# BLOCK 91

## DESIGN DRAWINGS

## BL 91 COMMENTS TO ADDRESS - POST DR I

## TERRACE PLAN - FLOOR 07

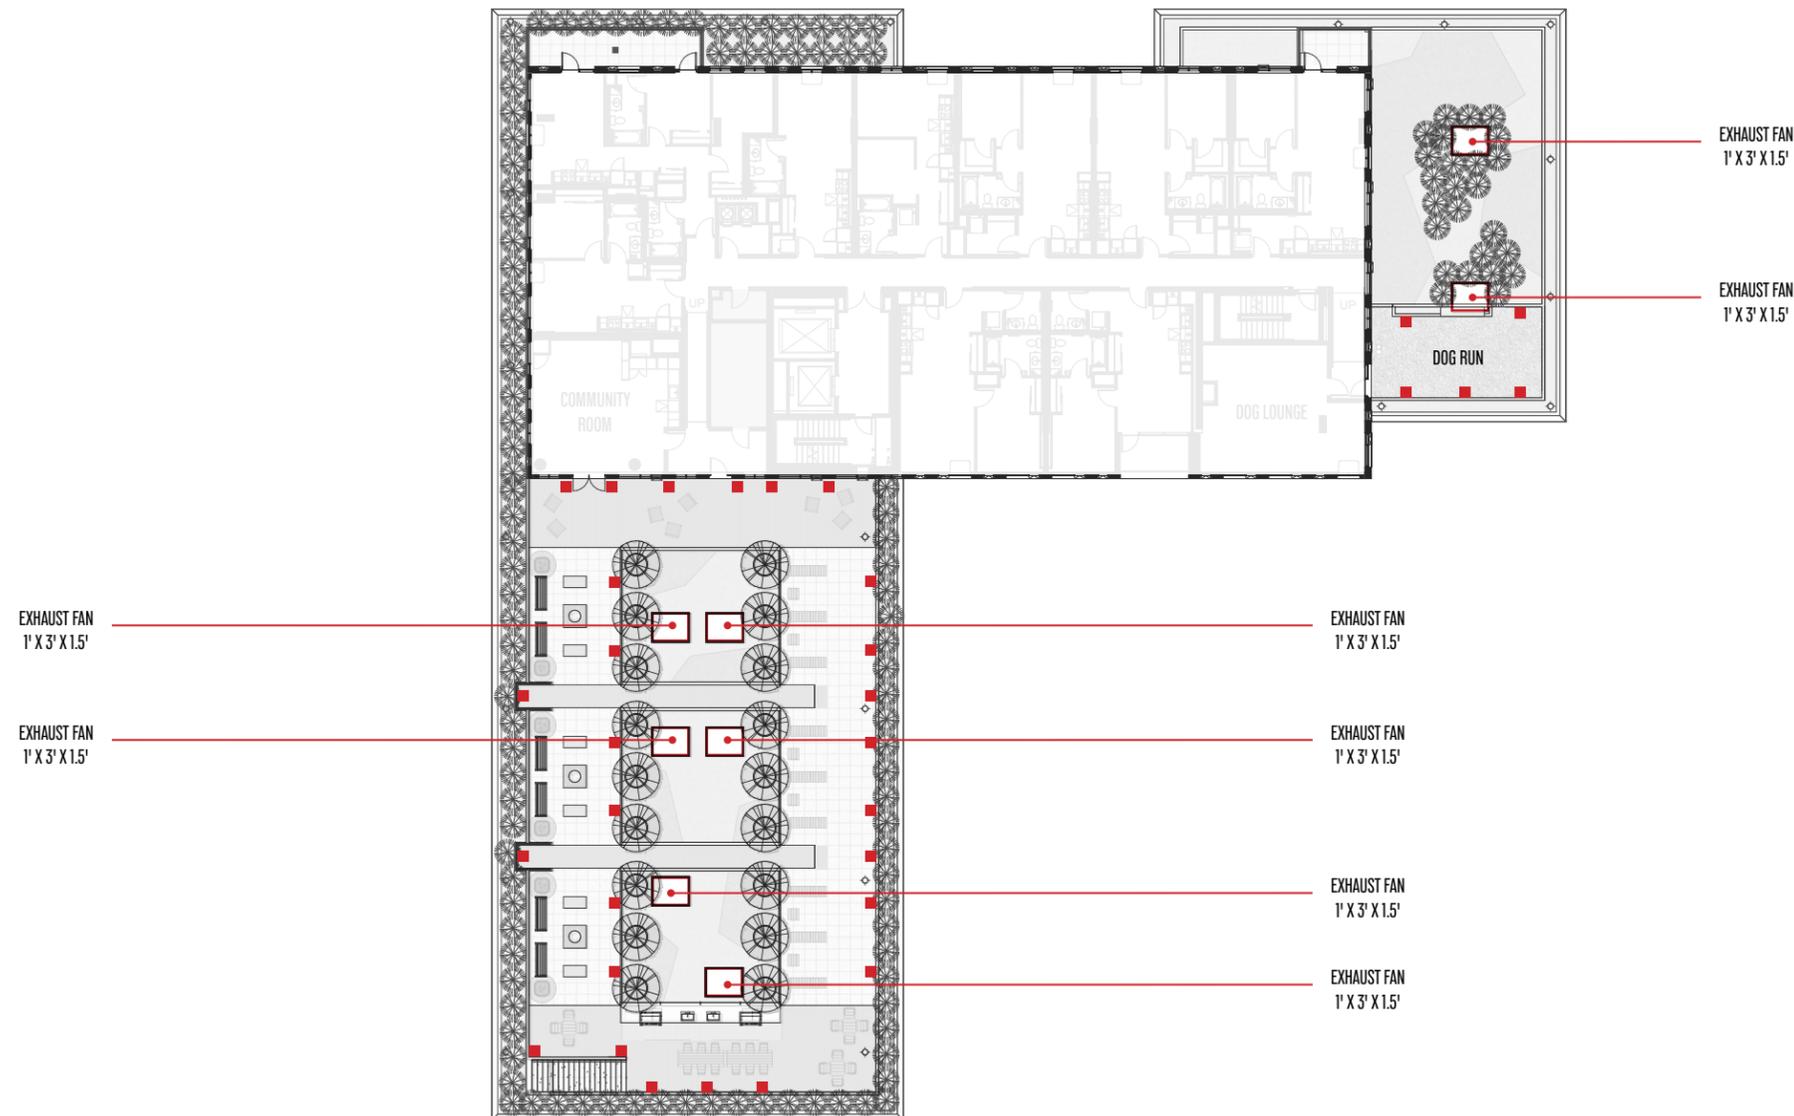
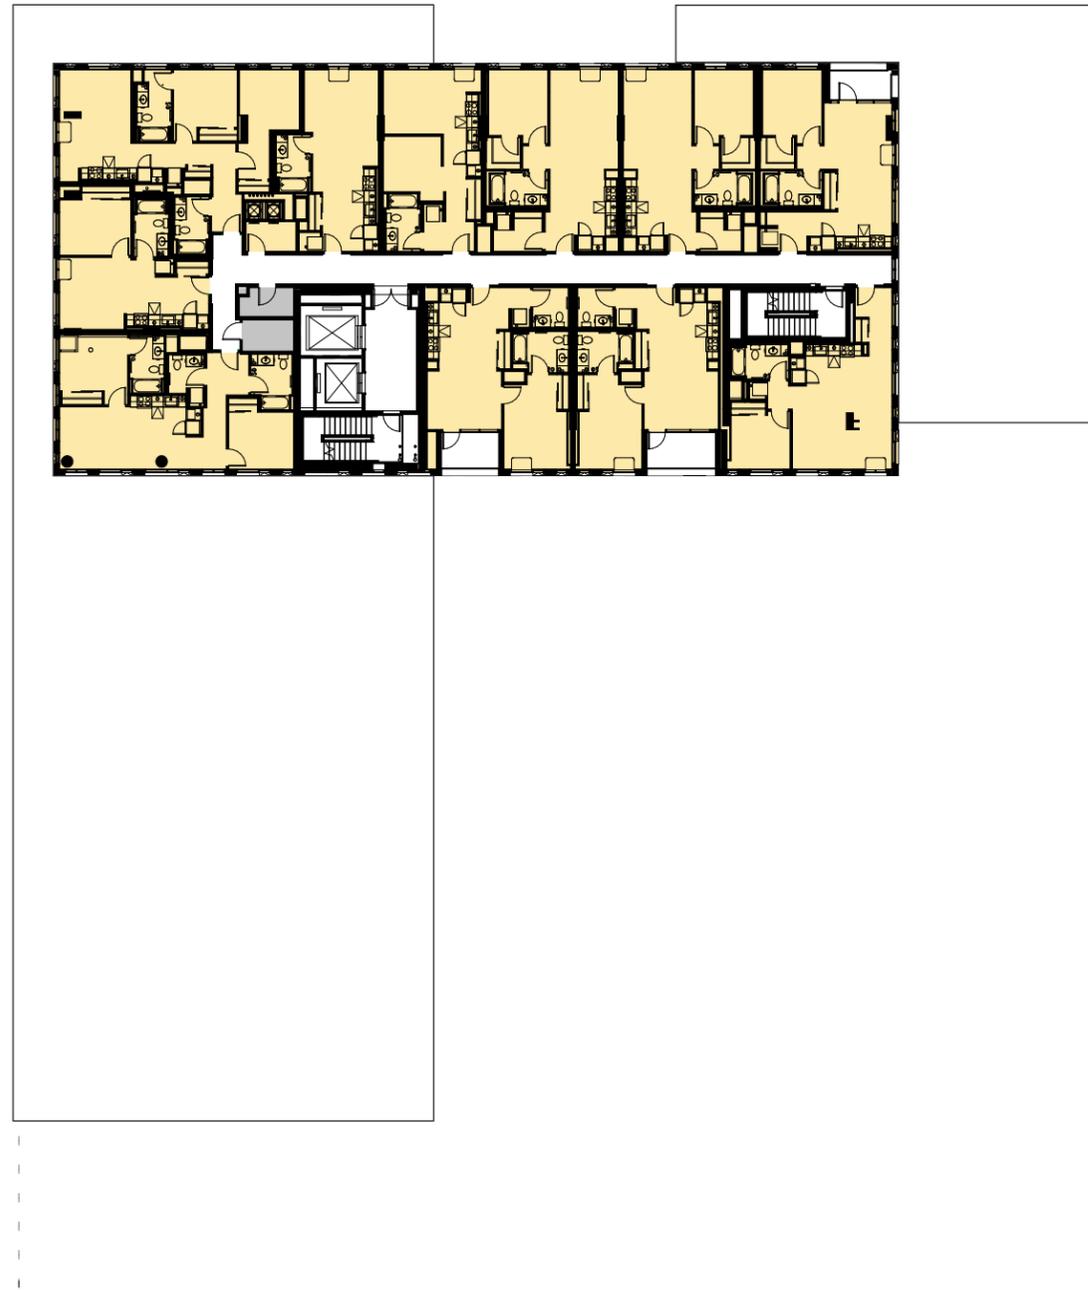
### *Landscape on terrace level*

*Material on West edge of 7th floor will perform differently than species on other sides.*

*GBD: A series of new plant species has been proposed, see landscape terrace plan spread for more information.*

# PASS THROUGH LOBBY AT HOLLADAY ST - DETAIL: 91 - 1

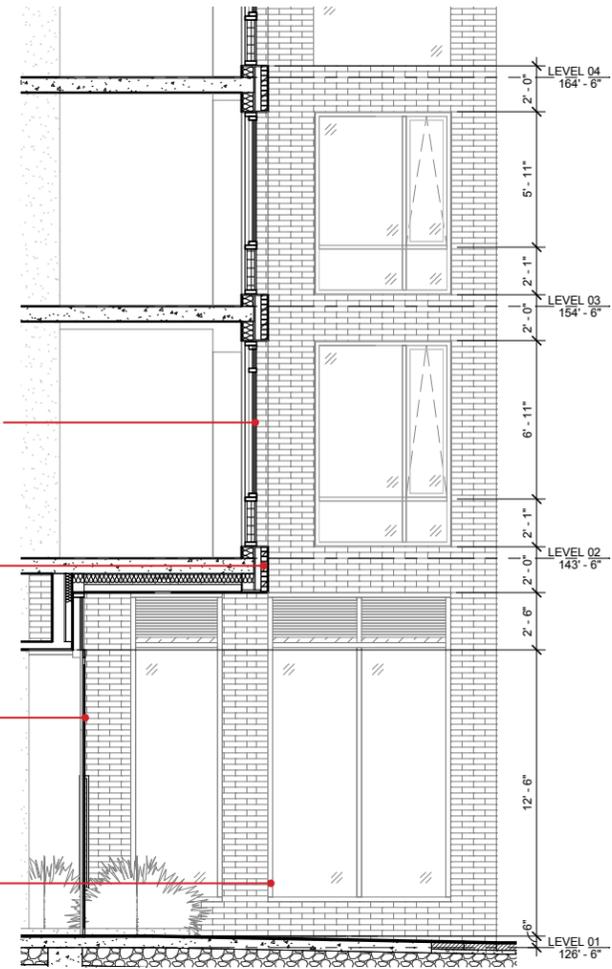
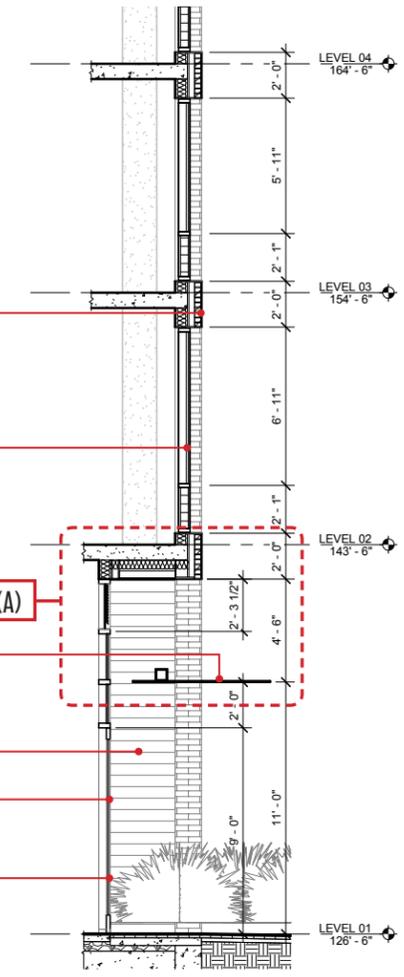
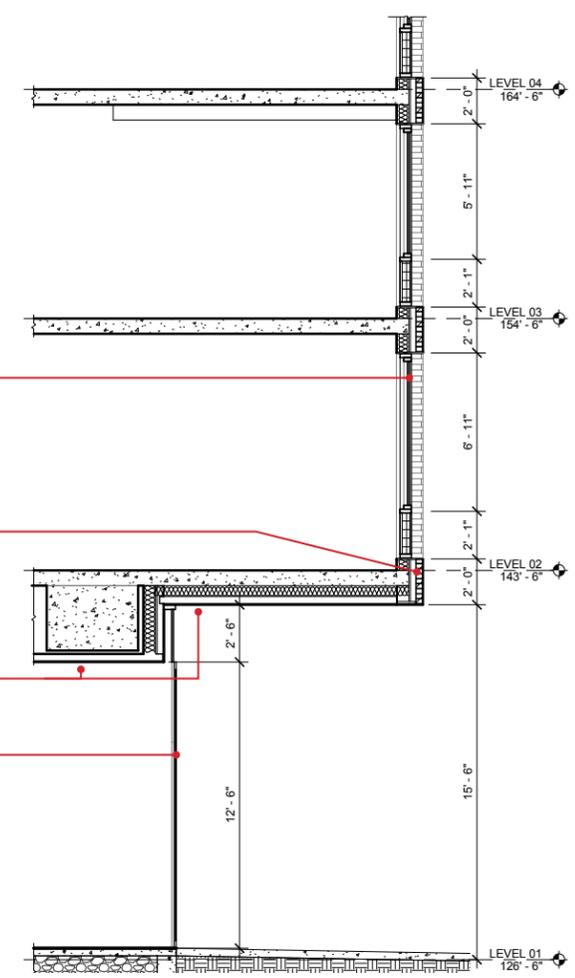
### *Pass-thru lobby*

*Diminishes presence of Water Street Gate entry.*

*Maybe completely open (no doors) or have it be a formal entry.*

*GBD: We believe it offers a pressure relief to surges of pedestrians from mass transit during events within the plaza. We have two options to present. One that makes the pass-thru into a lobby with visual porosity only, and another that turns the pass thru into a breezeway by integrating overhead security grills for security only. We believe that the original option presented with center pivot glass doors is the best solution. We have included these options for discussion with the commission.*

*GBD: We will want to design in the ability to secure. An option which incorporates an overhead security grill is included for discussion.*
